# Memo

**APPLICATION NO.** DVP07-0100      **OWNER:** Anthony Otto

**AT:** 1415-1417 Edgewood Dr      **APPLICANT:** Anthony Otto

**PURPOSE:** Supplemental Report to vary the height of a retaining wall from 1.2 m required to 5 m proposed and to vary the combined height of a retaining wall and fence from 2.0 m to 5.2 m.

FIGURE 3

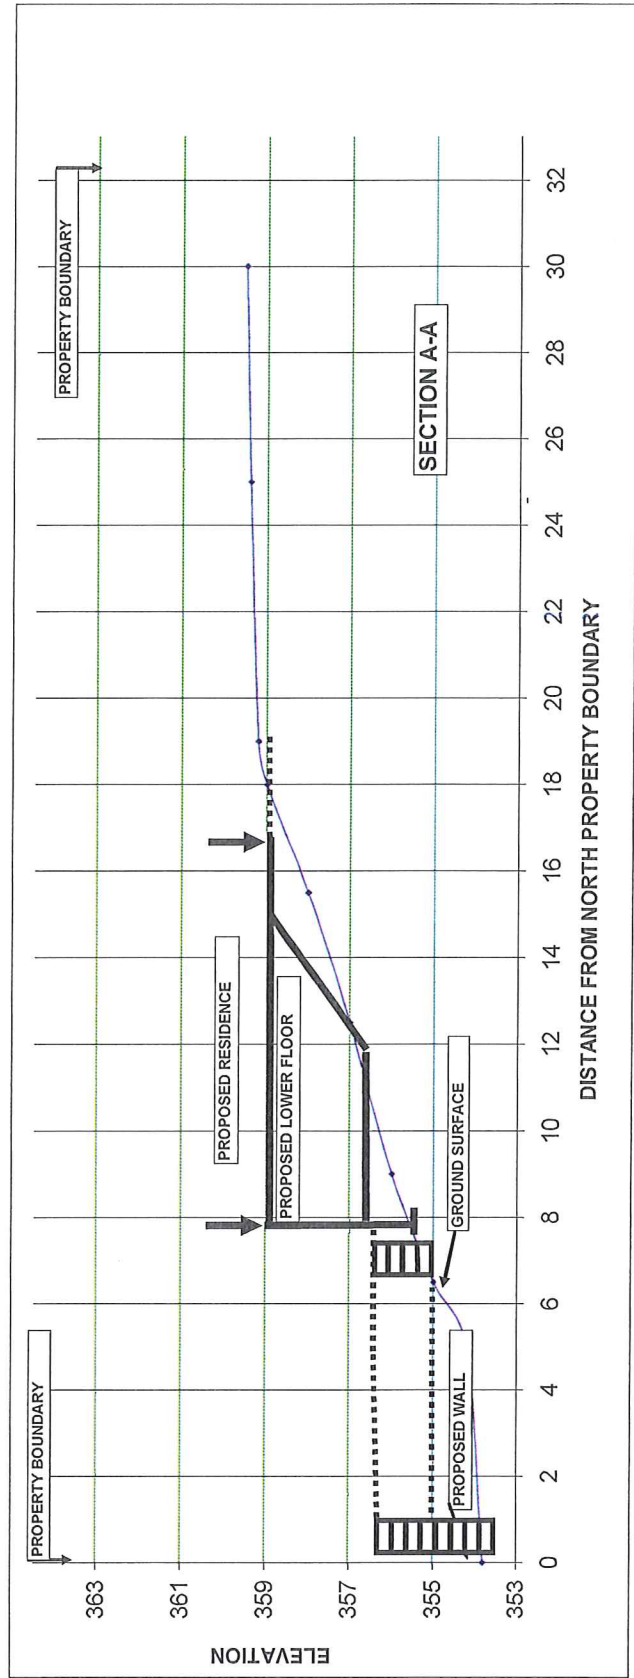
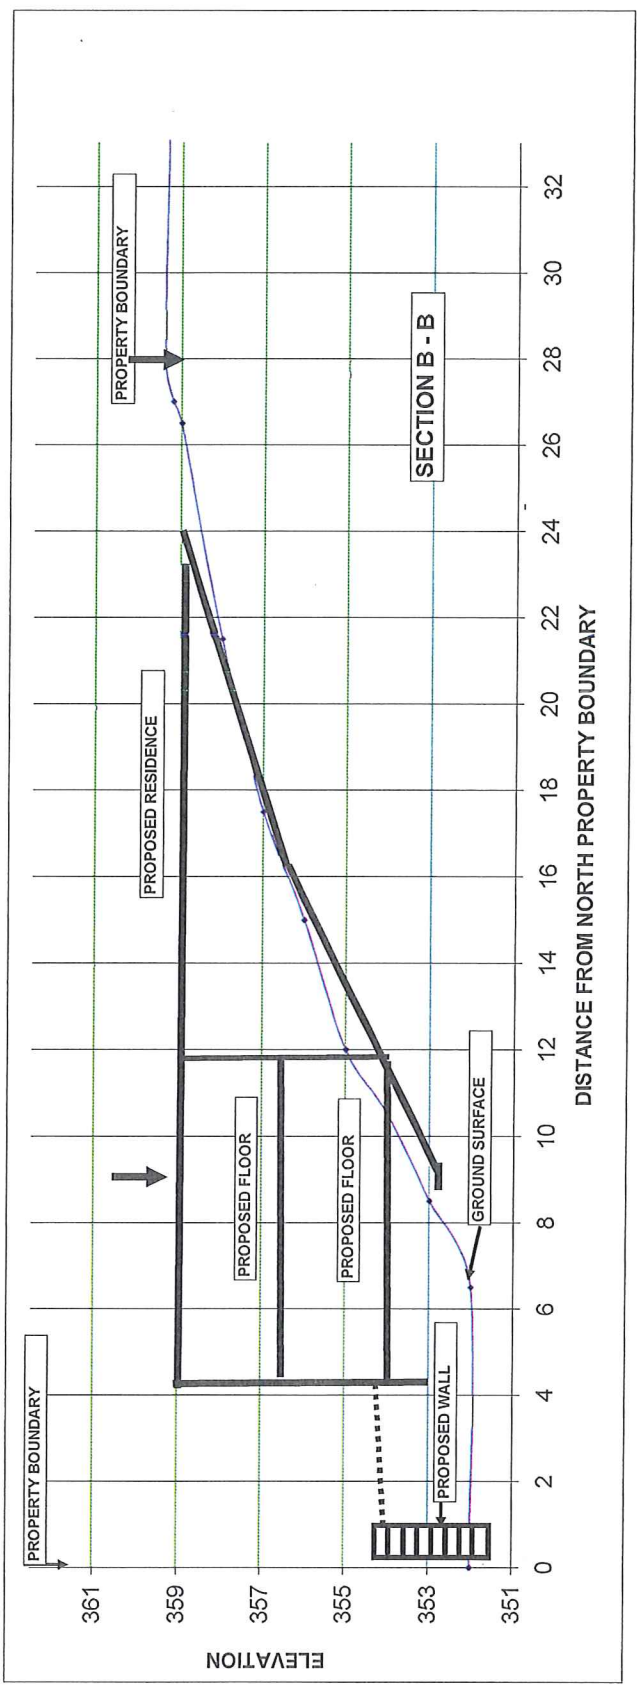
2) Provide at least two cross-sections showing the location of Footing and Foundation of the houses in reference to proposed retaining wall. Verify in extreme case, should the retaining wall fail, what the impact is on the structure and the adjacent properties.

on the footings will not affect the lock block wall as shown in the section on Figure 3 and 4. The location of the footings are outside the influence of the retaining structure.
